PIERCE TOWNSHIP ZONING COMMISSION

RE: ZC2022-004 Davis/Ninemile PUD R

PROJECT:
NINE MILE AND DAVIS ROAD DEVELOPMENT
NANCAROW M.S. #1747 & KNOX M.S. #4795
PIERCE TOWNSHIP, CLERMONT COUNTY, OHIO

CONCEPTUAL SITE LAYOUT - PUD - R

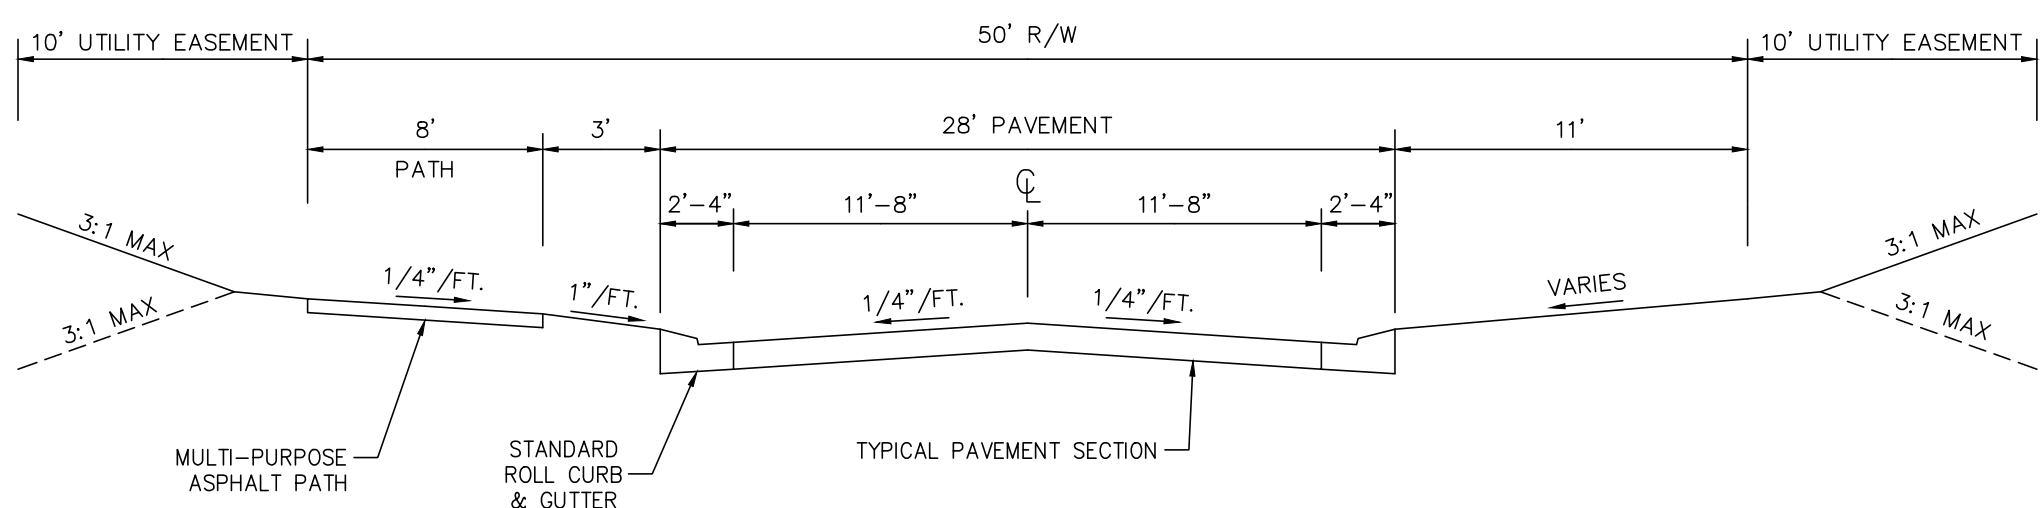
- 1) Compliant
- 2) Generally compliant. Some lot frontages not shown (See Lot 36 and 35).
- 3) Staff maintains the position that Ninemile generally and the intersection at Davis/Ninemile have potential safety issue, including geometric deficiencies.

- 4) Staff maintains the issue that geometric concerns remain and there are no plans to remedy the issue.
- 5) Deficient. Poor alignment of driveways. Access should be explored further east along Ninemile, despite the elevation changes. It is not clear to staff that this option, albeit potentially difficult, was sufficiently explored.

- 6) Complaint; second ingress/egress shown
- 7) Generally compliant. Trail system not entirely coherent.
- 8) Unresolved. It is not clear to staff that the Fire Department was contacted regarding this issue in order to reach a resolution.

- 9) Unresolved. See lot 29. A number of other lots are proposed with a steep ravine in the backyards.
- 10) Generally compliant, with the exception that there is no effort to retain the pond on site.

20) At least 9 lots encroach on the tree line and hillside.

21) Some lots are excessively short and panhandles should be avoided.

22) The trail system should connect externally and gaps need to be avoided.

23) Advise on the setback compliance of the high tension lines (2 installations) on site. a. Accessory structures have multiple potential obstruction areas due to the power line easements. Please advise.

24) Tree protection not detailed nor illustrated. Existing vegetation should be preserved to the greatest extent feasible.

26) Open space areas must be 30' minimum in width

PRELIMINARY WOTUS ASSESSMENT

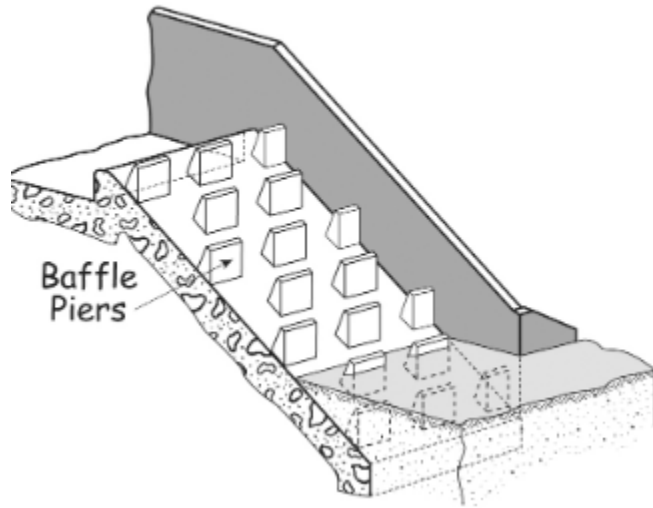
- a. There is a 0.18 acre Freshwater Pond habitat on site classified as a PUBGh proposed to be entirely disturbed. Advise of efforts to preserve/enhance this site

14) Freshwater wetland in the center of the site is being removed.

The pond has been evaluated the wetland scientist. His recommendations were sent to staff.

There is no freshwater wetland in the center of the site. The site has been evaluated by a wetland scientist and this information has been provided to staff. There are “fringe” wetland plants that are approximately .001 acres surrounding the small pond that is approximately .179 acres. There is no observed offsite or onsite connection to any stream; therefore, the pond would be considered isolated and likely not regulated by the USACE. As a condition of approval, the client agrees to get any permits required by the state or USACE per the PUD requirements set forth in the zoning ordinance.
